CITY OF SOUTH BAY, FL ITB 2023-03

S2 AREA DRAINAGE IMPROVEMENTS

ADDENDUM No. 2

ISSUED JANUARY 17, 2024

SHEET NO. 17

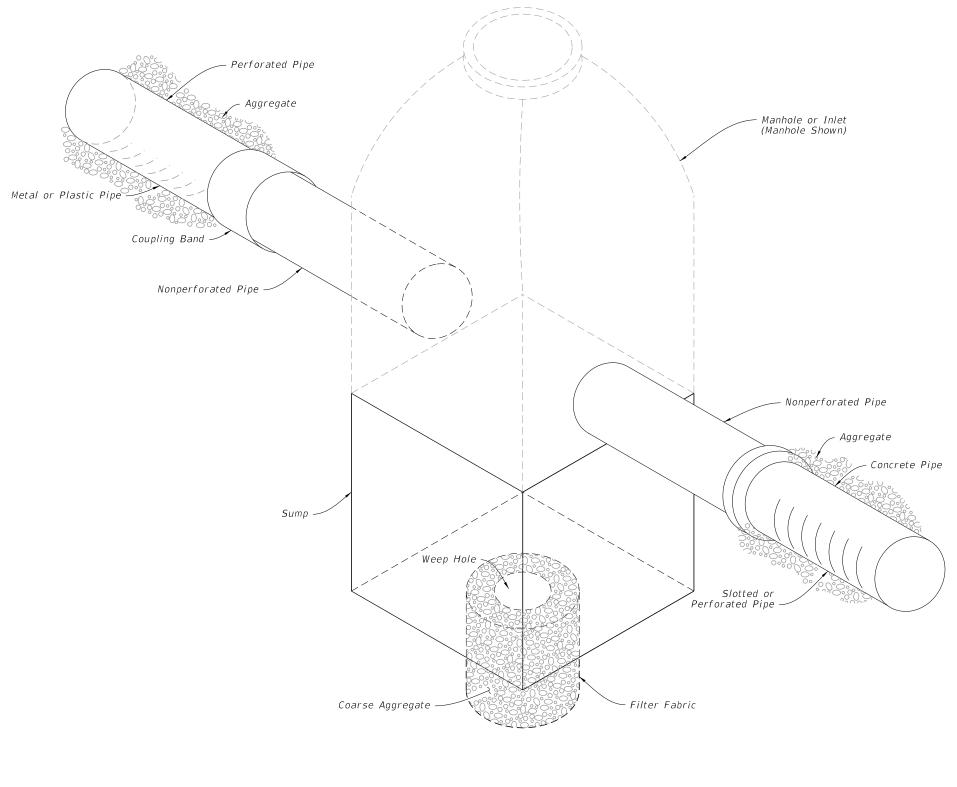
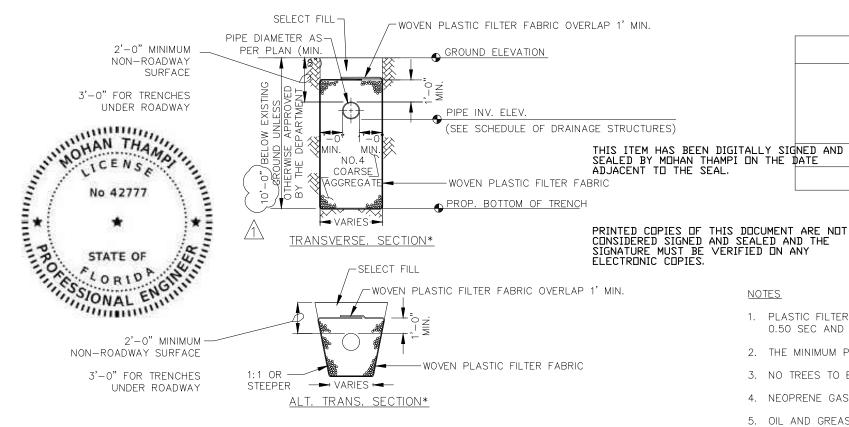
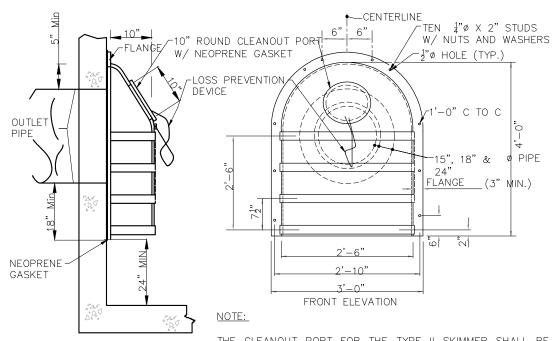
- 1. *Question:* Since the Soil Borings provided stop at 8' below grade there is no way for the contractor to know if the trench walls will stand vertical per the French Drain details on Sheet #17, should we use the FDOT Standard Index 443-001 for the entire run of drainage?

- Answer: Sheet No. 17 with the French Drain detail has been revised to show that the trench depth is 10 feet. This detail indicates vertical and alternate transverse trench wall details. Further, the inlet structures S-2, MH-1, S-6, S-12, S-13, S-15, S-16, S-17, S-18, S-19, and S-20 between the French Drain can have weep holes as per FDOT Standard Index 443-001. Following FDOT Standard Index 443-001 is acceptable as it is a similar detail but HDPE can be used for the exfiltration pipe instead of RCP as the FDOT detail shows.
